Project Title: General Atomics (BP-2023-34420) Hydrology File # \_\_\_\_\_

**Re: General Atomics Office  
14820 Central SE  
Traffic Circulation Layout  
Engineer's/Architect's Stamp 5-24-2024 (L23D011A)**

Based upon the information provided in your submittal received 5-29-2024, the above referenced plan cannot be approved for Building Permit until the following comments are addressed:

## TYPICAL BIKE RACK

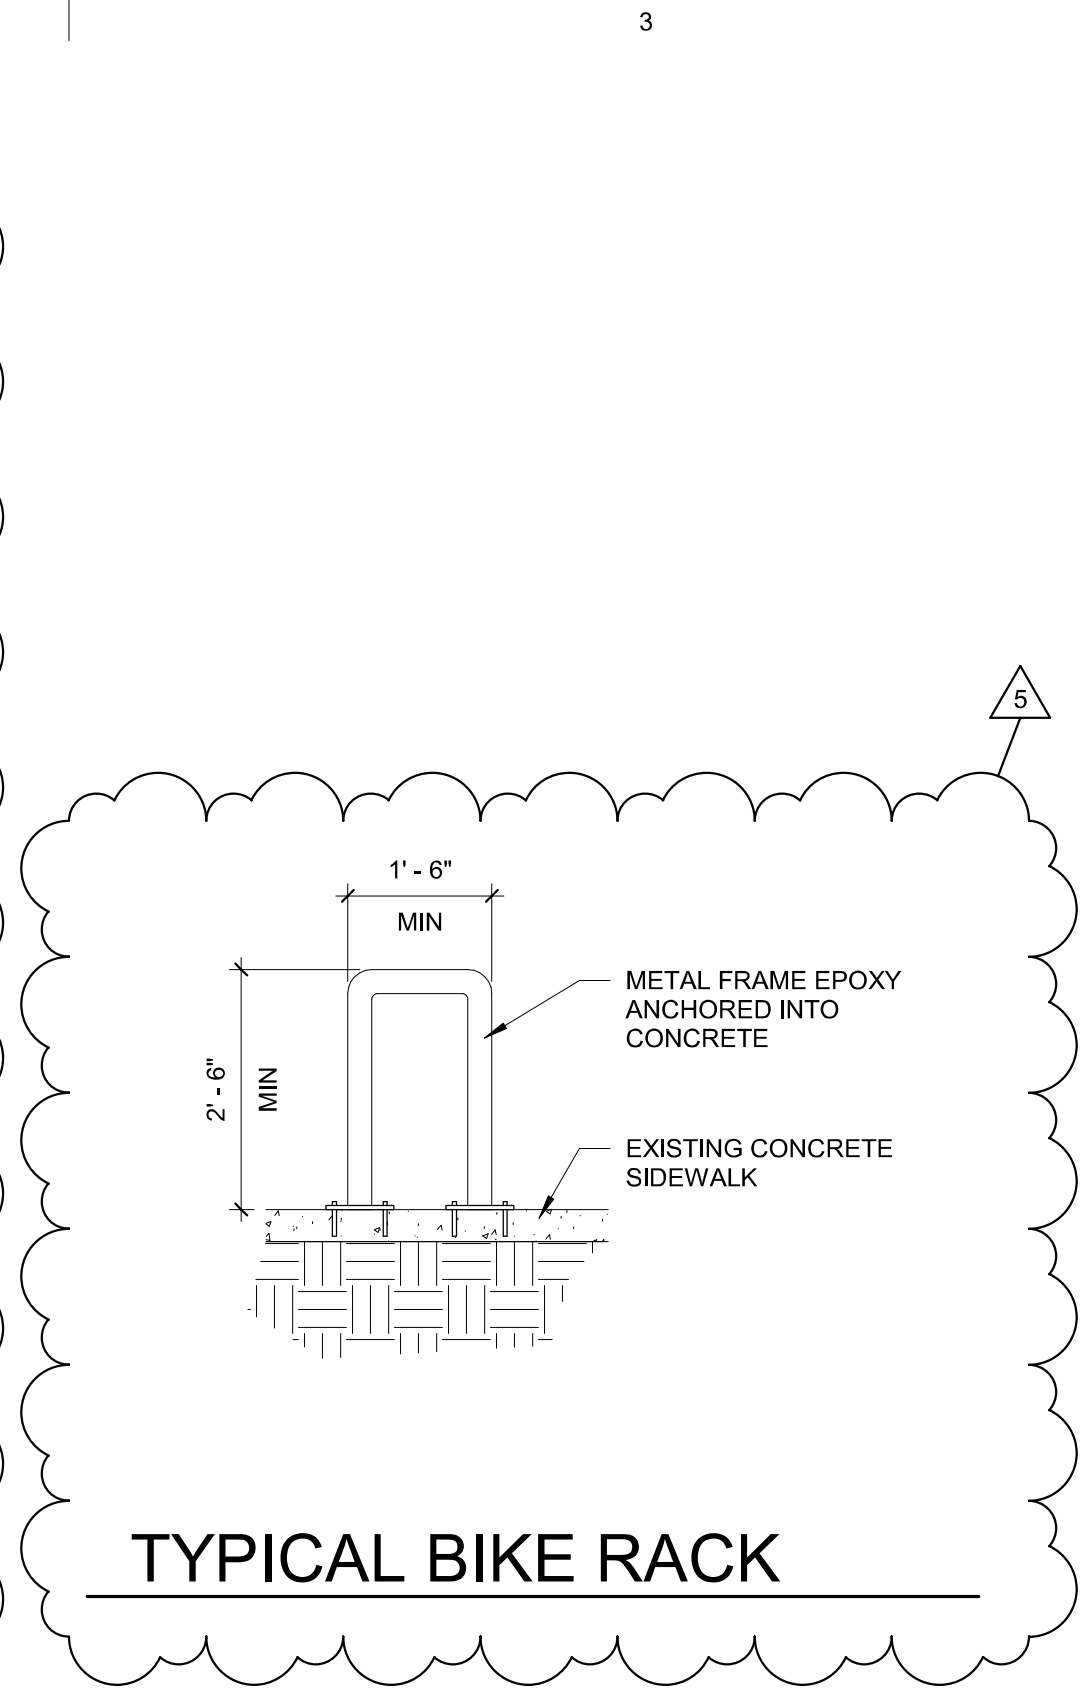
9. All bicycle racks shall be designed according to the following guidelines: [Bike racks are shown on A3/AS101, and detail view is added to AS101.](#)

- a. The rack shall be a minimum 30 inches tall and 18 inches wide. Show your details.
  - b. The bicycle frame shall be supported horizontally at two or more places. Comb/toaster racks are not allowed.

## A3 SITE PLAN

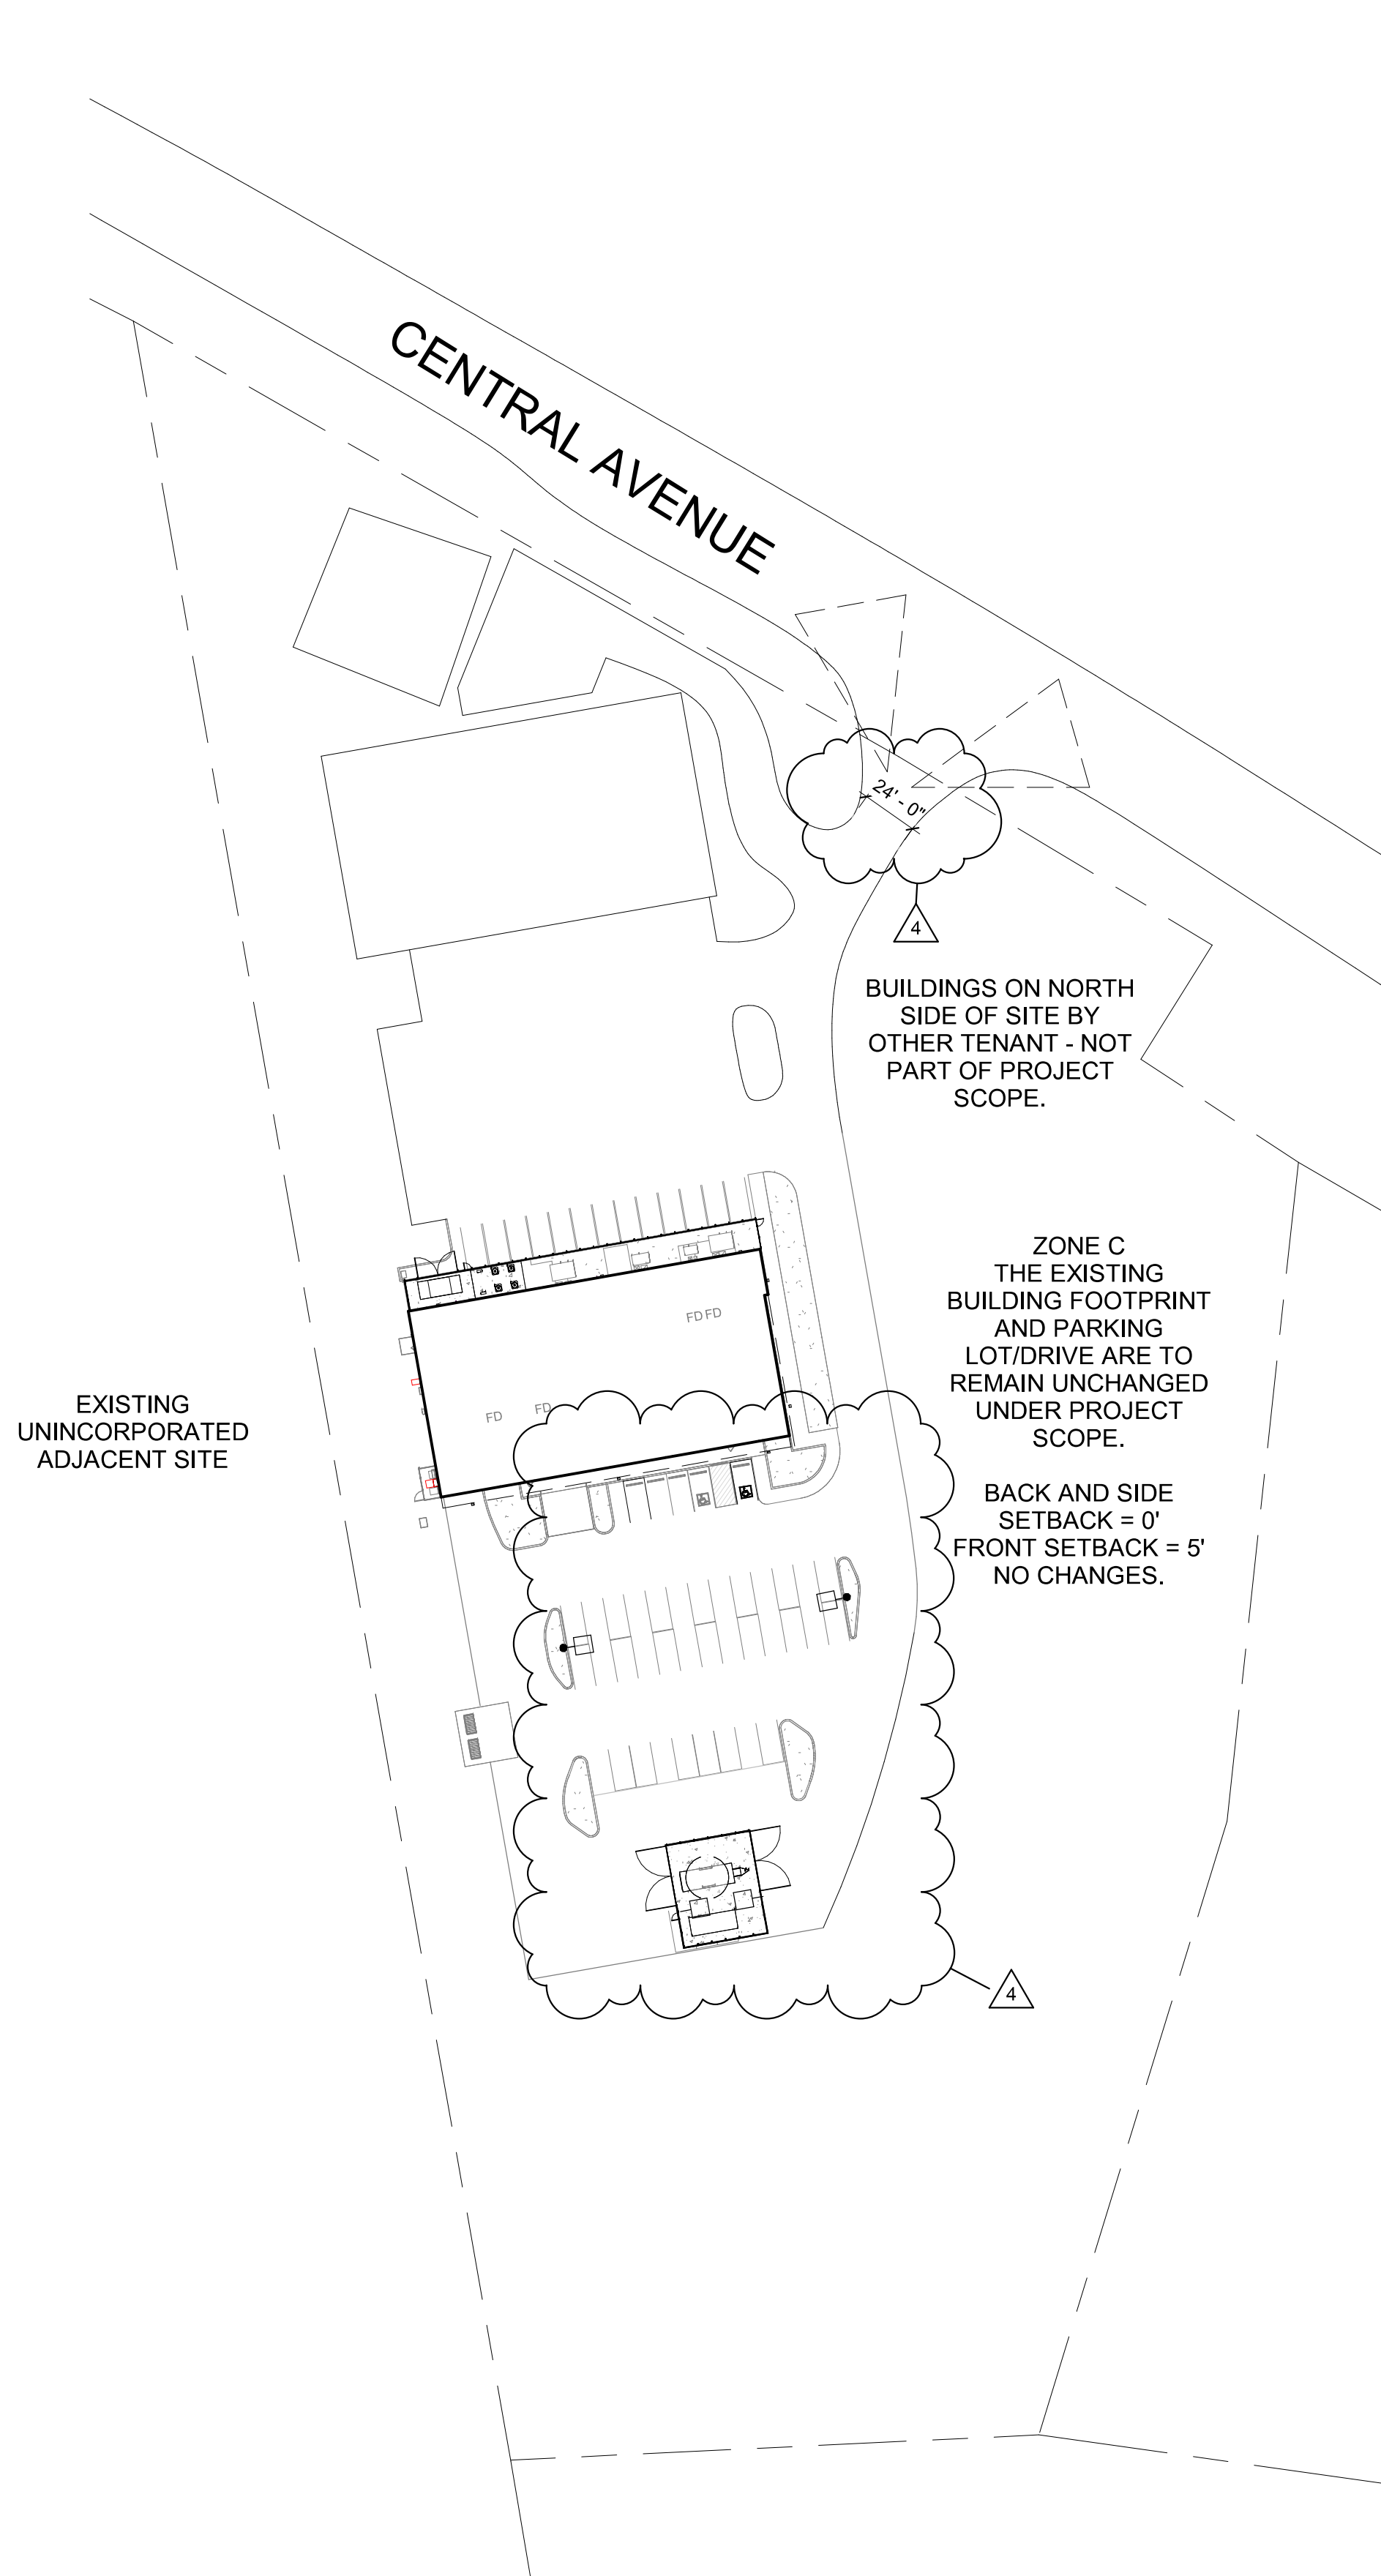
6. The ADA accessible spaces must include an access aisle. Van accessible aisles should be 8ft wide; all others should be 5ft wide.

8. Motorcycle parking spaces shall be designated by its own conspicuously posted upright sign, either free-standing or wall mounted per the zoning code. [Location of the motorcycle sign is shown on A3/AS101.](#)

13. Show all drive aisle widths and radii. Some dimensions are not shown.

20. All one-way drives shall have "One Way" and "Do Not Enter" signage and pavement markings. Please show detail and location of posted signs and striping. [Please see revised AS101, one way drive has been removed.](#)

Dimensions revised per our discussion are shown on A3/AS101.

Dimensions revised per our discussion are shown on A3/AS101. The owner's intent is to keep the existing access to the site as is. Approximate dimensions of the existing layout with the main access at 24'-0" and various other aisles ranging from 23'-8" to 30'-0"+ are shown on A3/AS101.

## A1 OVERALL SITE PLAN

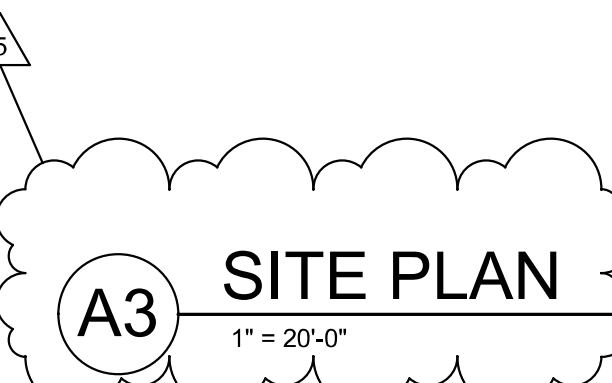
21. Show the clear sight triangle and add the following note to the plan: "Landscaping and signage will not interfere with clear sight requirements. Therefore, signs, walls, trees, and shrubbery between 3 and 8 feet tall (as measured from the gutter pan) will not be acceptable in the clear sight triangle. [Clear sight triangles are shown on A1/AS101, and Note F added under General Notes.](#)
